HITACHI MICROCOMPUTER TECHNICAL UPDATE

DATE	27 July 2000	No.		TN-H8*-179A/E				
THEME	Supplement and change of "H8/3857 Series, H8/3854 Series Hardware Manual "							
CLASSIFICATION	Spec change Limitation on Use							
PRODUCTNAME	H8/3857series,H8/3854series			Lot No.etc	All Lot			
REFERENCE	H8/3857 Series, H8/3854 Series	Re	v.	Effective Date	Eternal			
DOCUMENTS	Hardware Manual(ADE-602-175A)			From	now

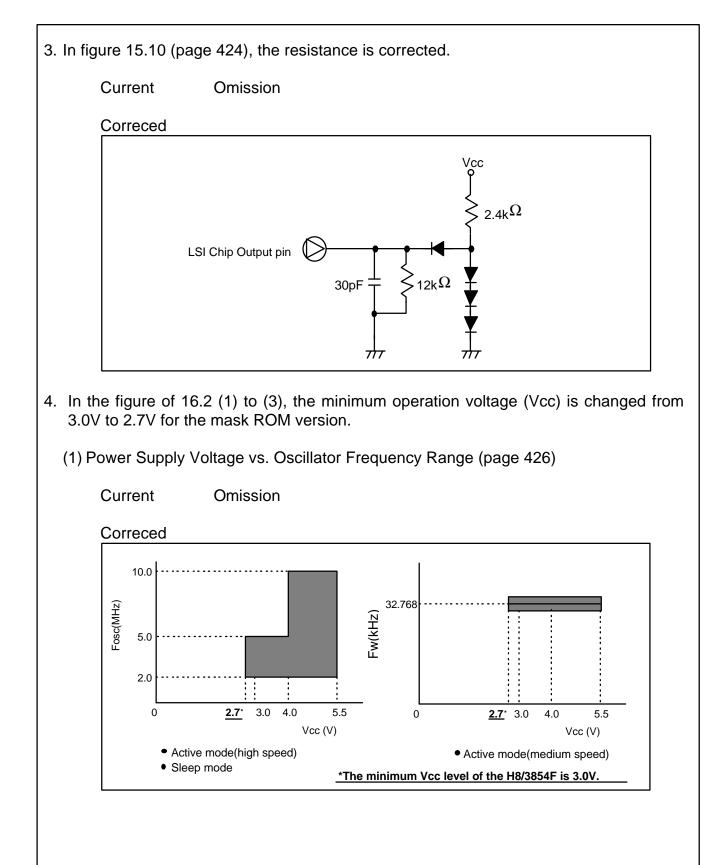
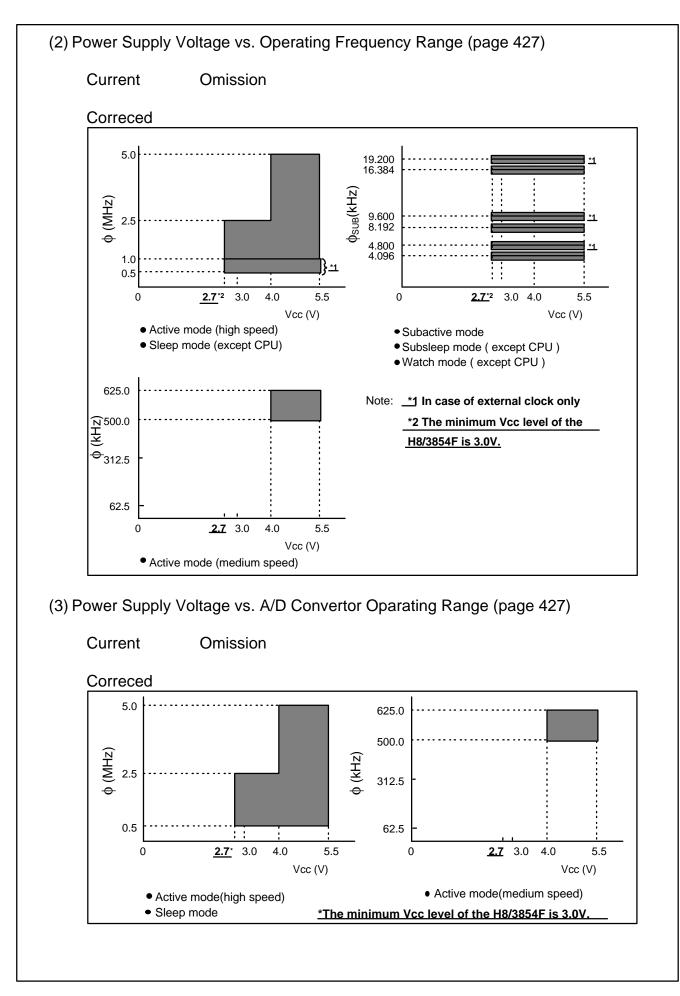
1. In table 4.2(page 98), the minimum operation voltage (Vcc) is changed from 3.0V to 2.7V for the mask ROM version of H8/3852, H8/3853 and H8/3854.

Current (Vcc = 3.0 V to 5.5 V,.....

Correced

(Vcc = 2.7 V to 5.5 V of the mask ROM version of H8/3852, H8/3853 and H8/3854, Vcc = 3.0V to 5.5V of H8/3854F and H8/3857 series,....
